27 October 2023  
Our File Ref: B23312AL001  
Contact: Bridget Wouts

RE: **LINK ROAD MIXED USE PRECINCT – BANKSTOWN AIRPORT**  
**AIRPORT SAFEGUARDING ASSESSMENT – PRELIMINARY ASSESSMENT**

L+R Airport Consulting were engaged by Bankstown Airport Limited (BAL) to undertake an airport safeguarding assessment at key design documentation stages through the Major Development Plan process as it relates to Bankstown Airport against the National Airports Safeguarding Framework (NASF) Guidelines. This assessment is based on the Preliminary Documentation stage.

FUTURE OBSTACLE LIMITATION SURFACES BANKSTOWN AIRPORT MASTER PLAN 2019

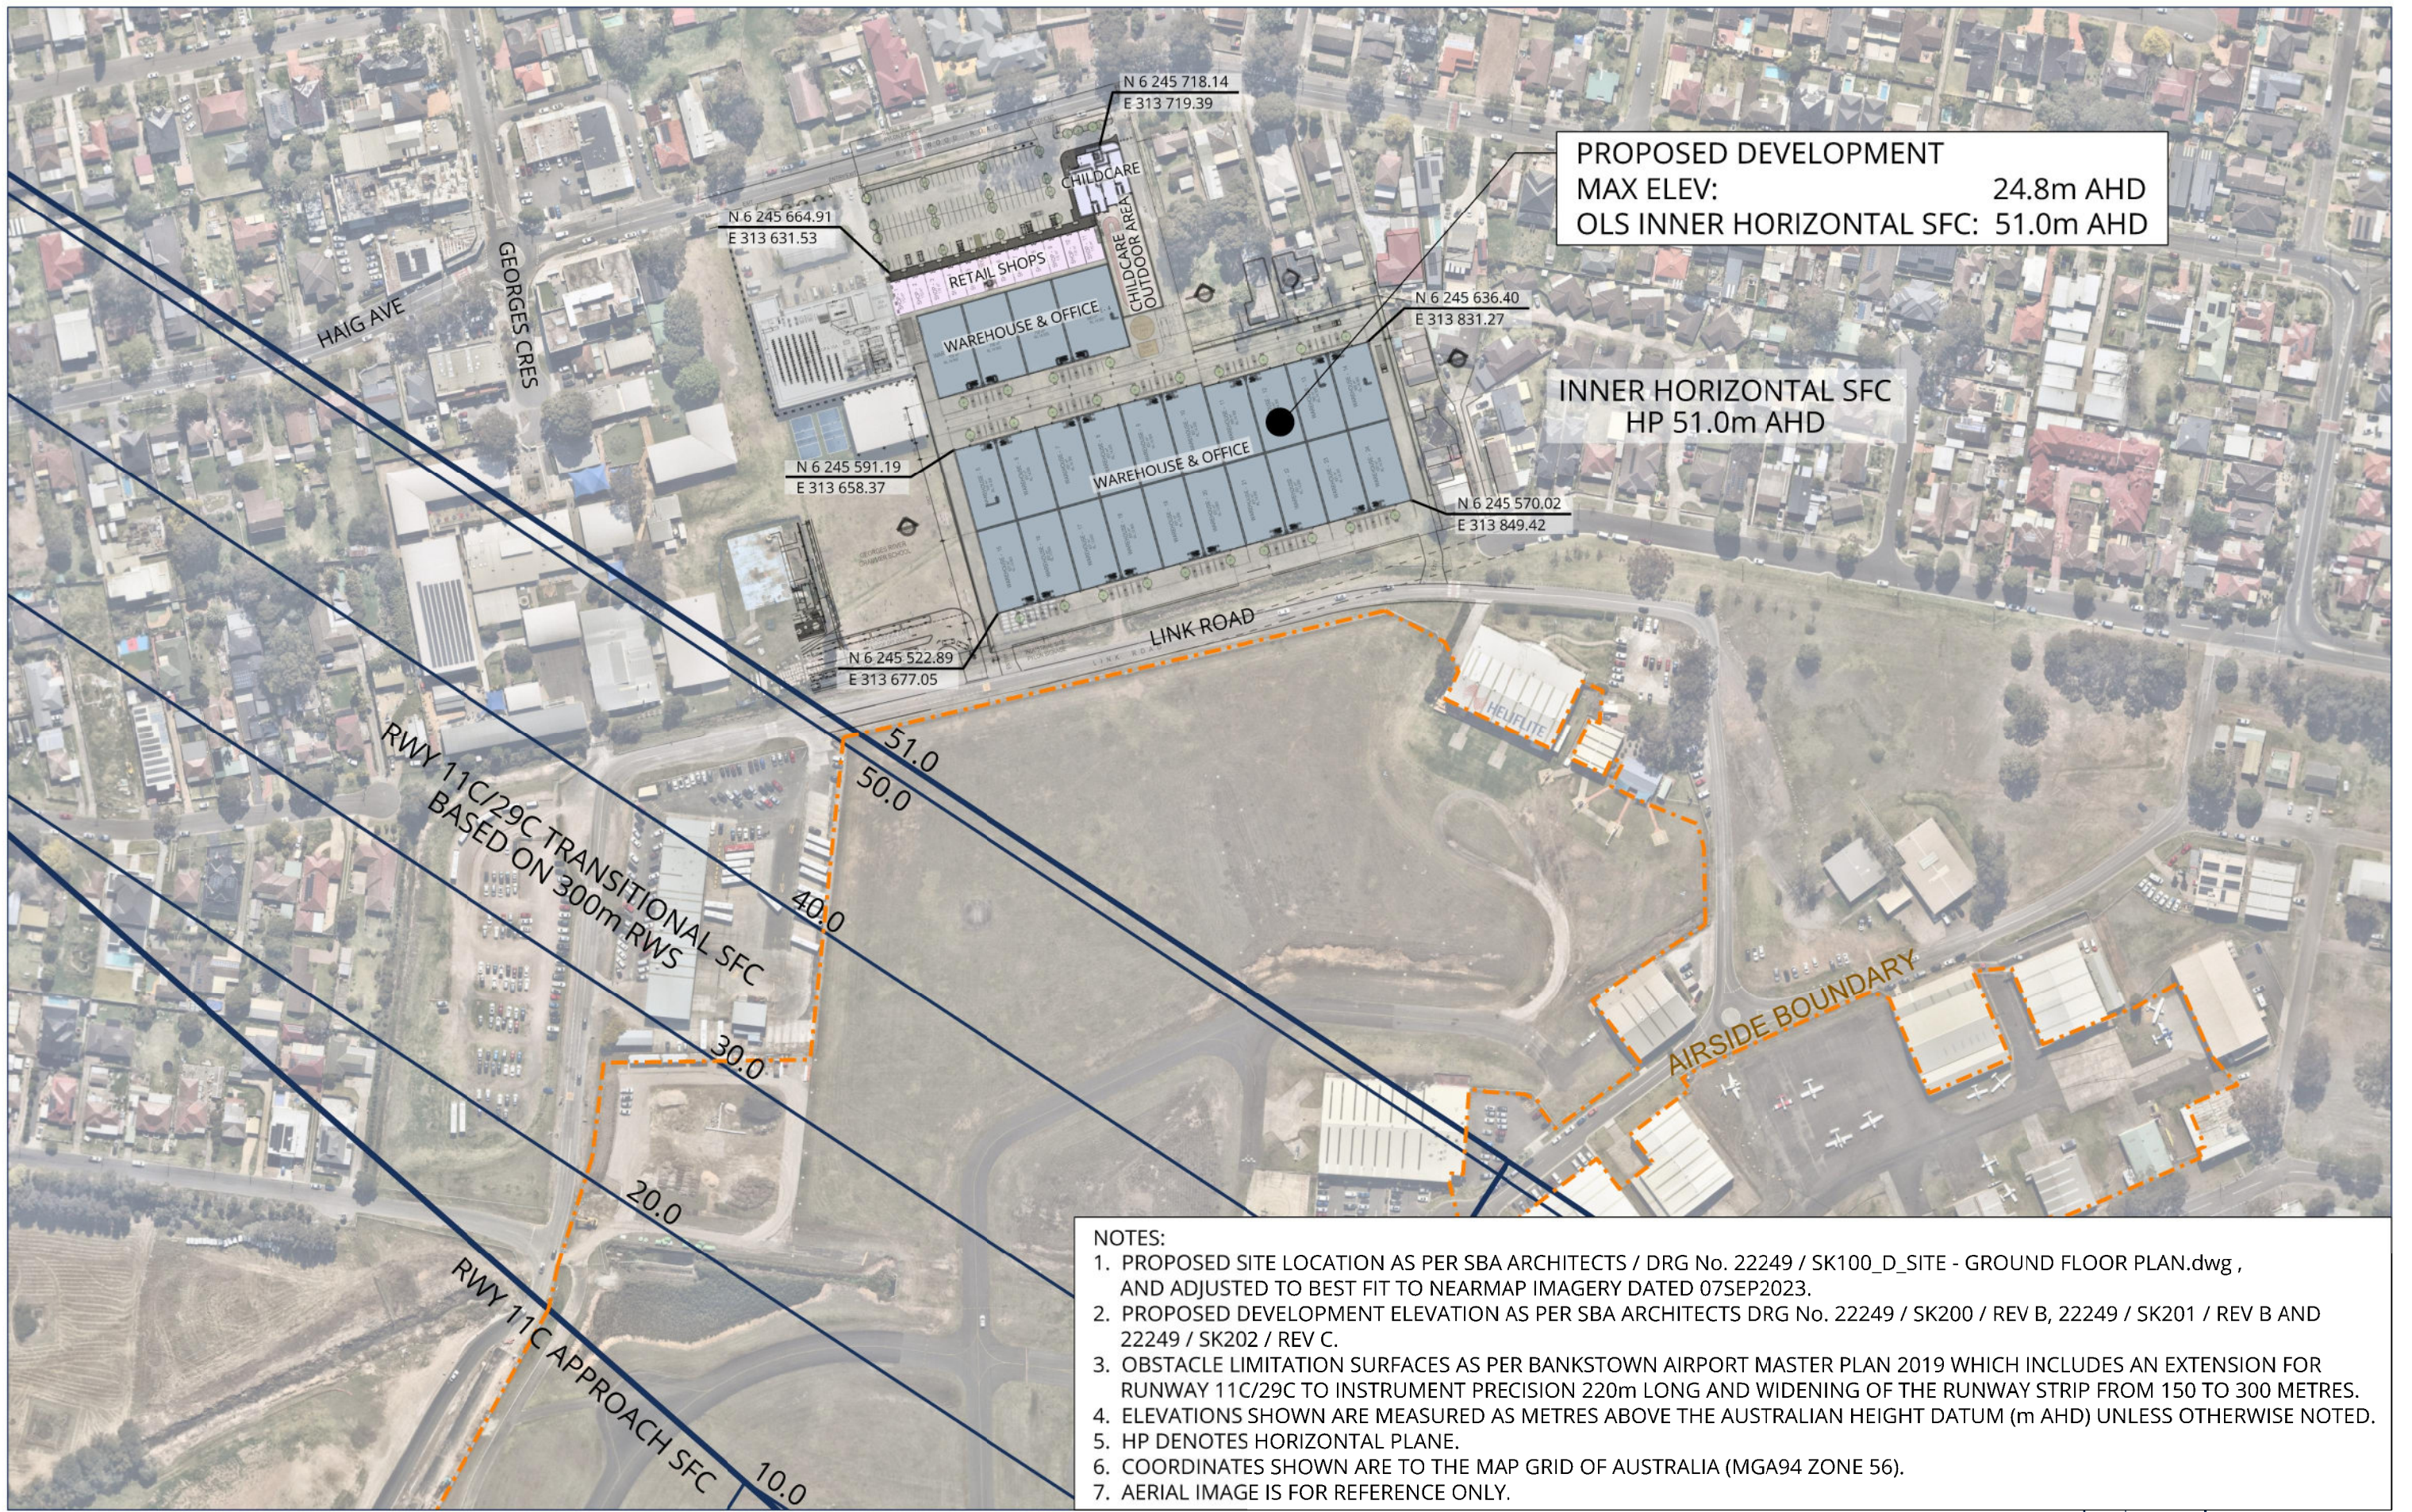
The proposed development is also within the extents of the Bankstown Airport Master Plan 2019 OLS which allows for Runway 11C/29C to be extended and provided with a precision instrument approach. The proposed development at a maximum elevation of 24.8 m AHD will not infringe the Bankstown Airport Master Plan 2019 OLS inner horizontal surface at 51.0 m AHD as illustrated on Figure B23312/02.

**BANKSTOWN AIRPORT LIMITED**  
 LINK ROAD MIXED USE PRECINCT - AVIATION ASSESSMENT  
**HELI OLS - BANKSTOWN AIRPORT**

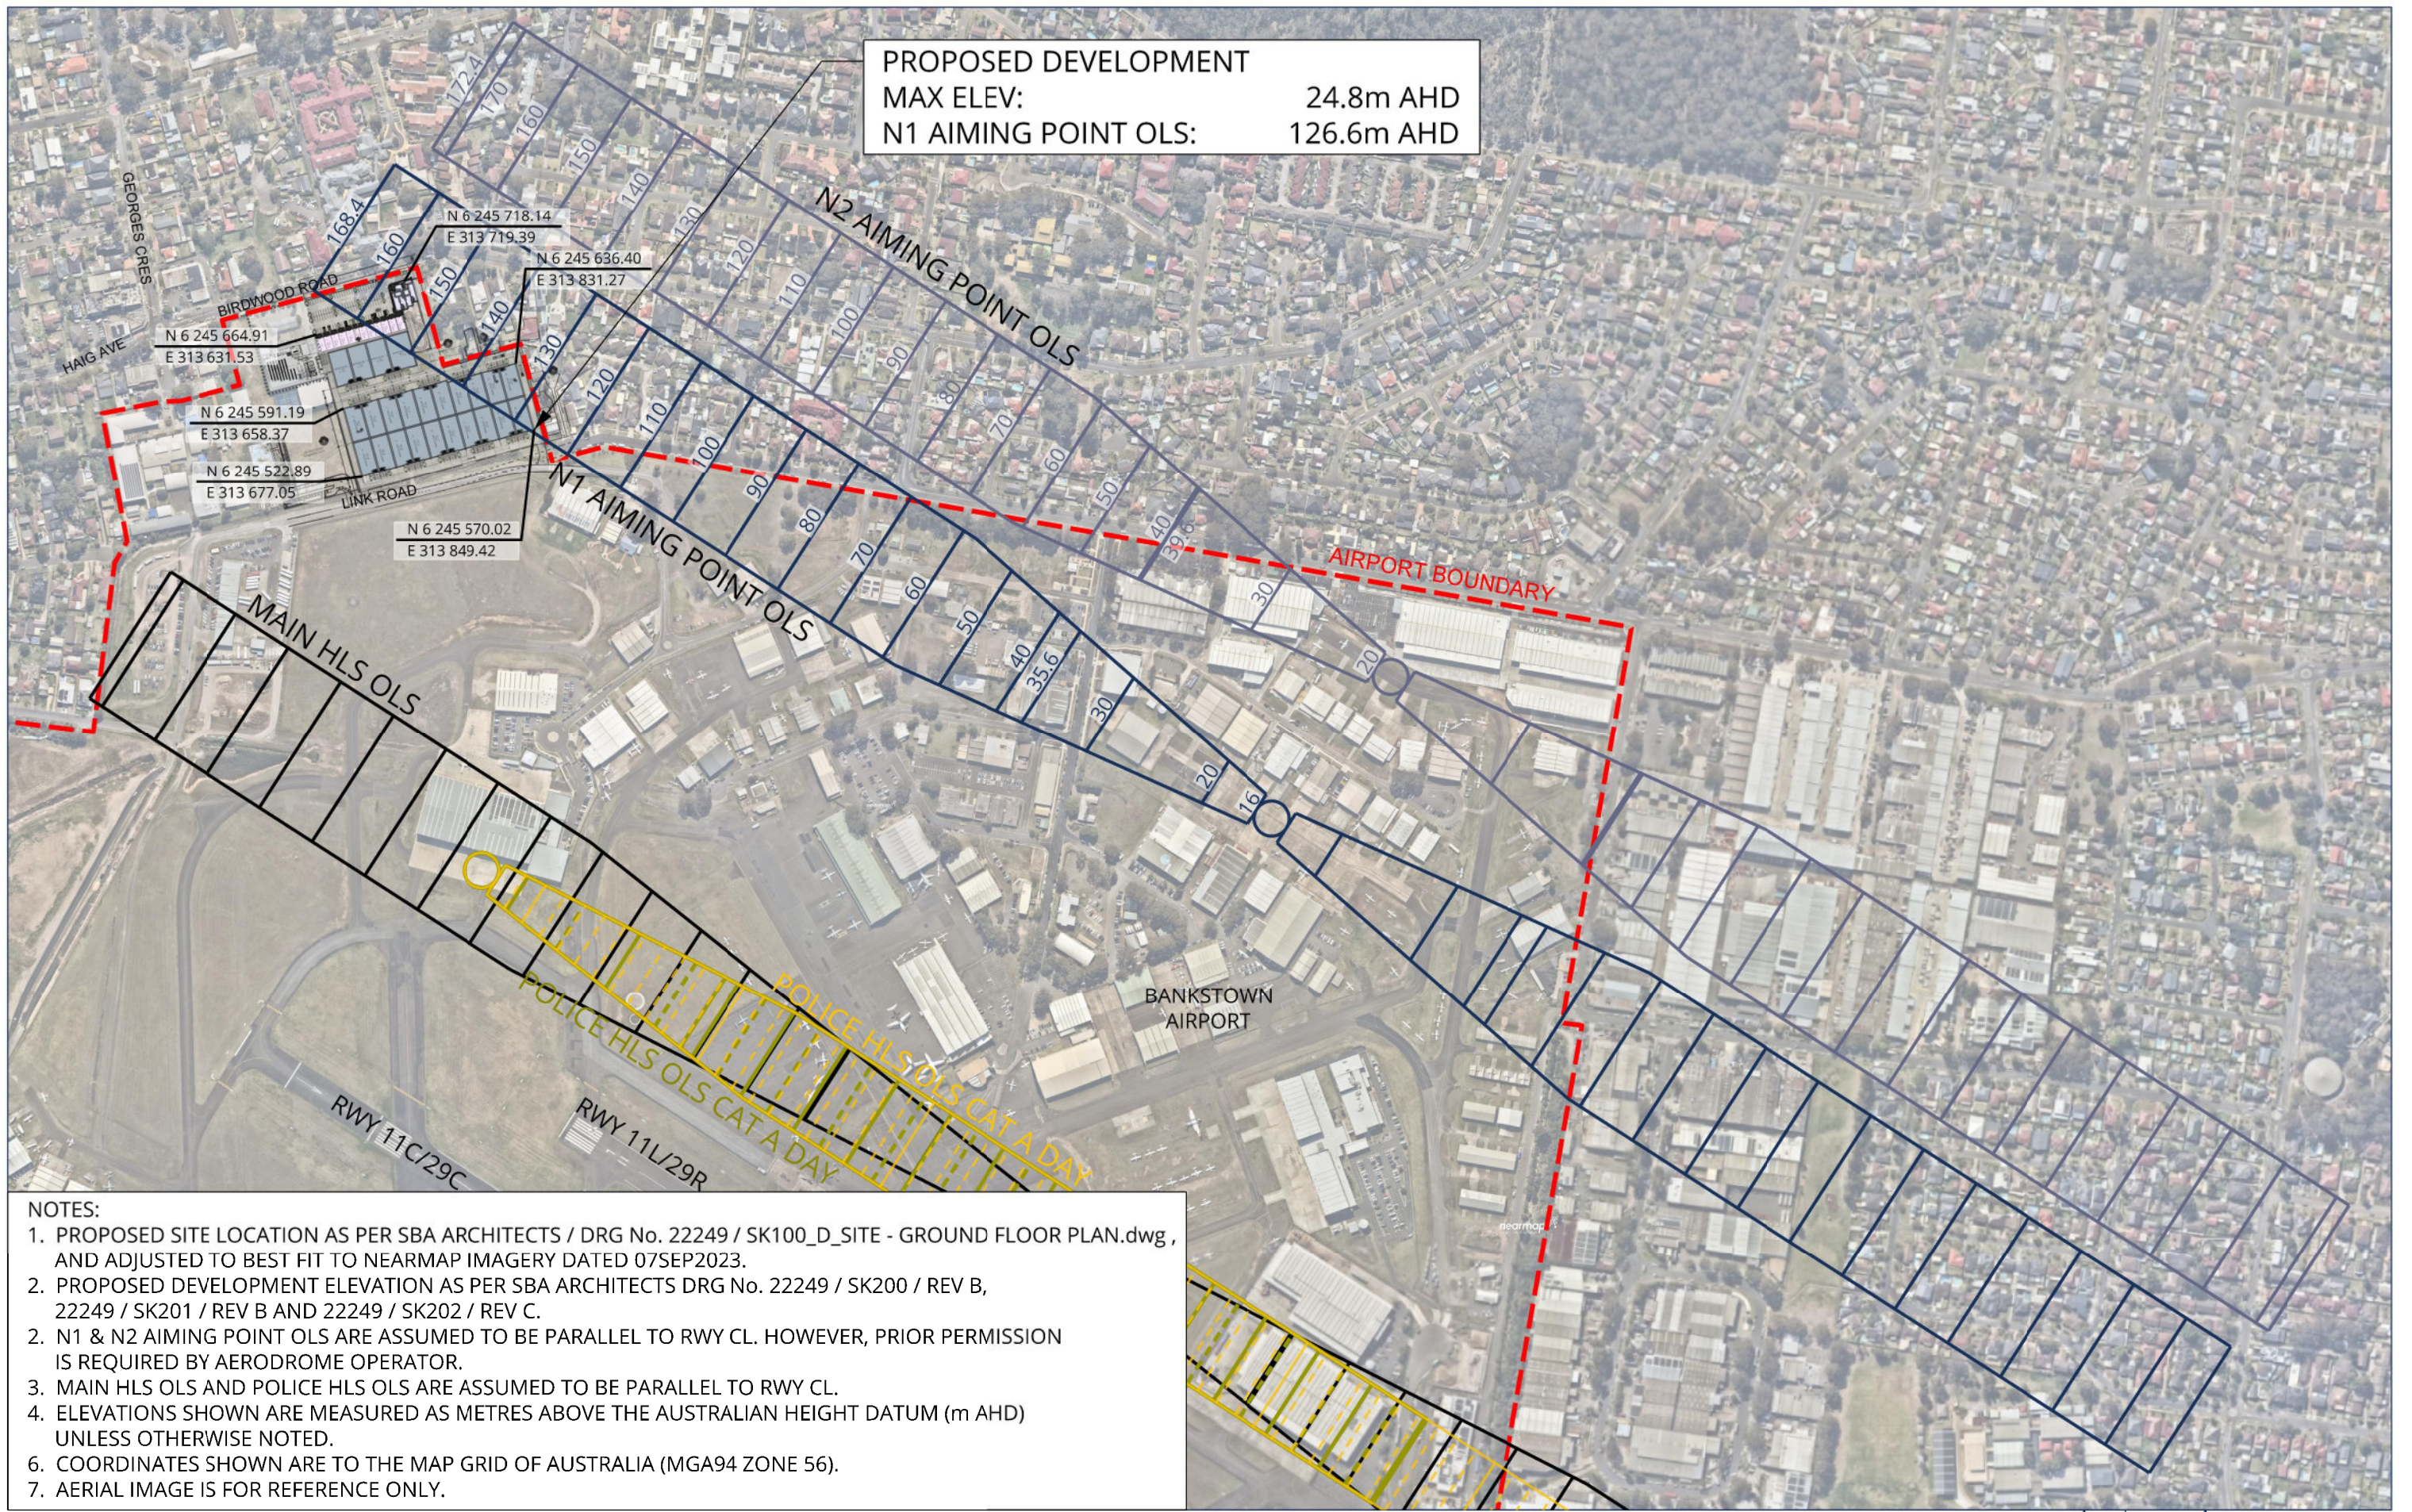
#### 2.1.3. Helicopter Landing Sites

Bankstown Airport has a Main HLS located centrally to the runway environment and north of Runway 11L/29R. Aiming points are provided on Taxiway N2 and west of Taxiway N1. There is also an additional HLS being considered on the POLAIR apron on the northern side of the runways as illustrated in Figure B23312/03. All flight paths operate parallel to the runway centrelines so as not to cause traffic conflicts with fixed wing operations.

The proposed development is within the extents of the existing Taxiway N1 aiming point OLS. The proposed development at a maximum elevation of 24.8 m AHD would remain well below this OLS which is at 126.6 m AHD at the closest point of the development site.

The proposed development is outside the lateral extents of the Main HLS, Taxiway N2 Aiming Point and the police HLS OLS at Bankstown Airport.
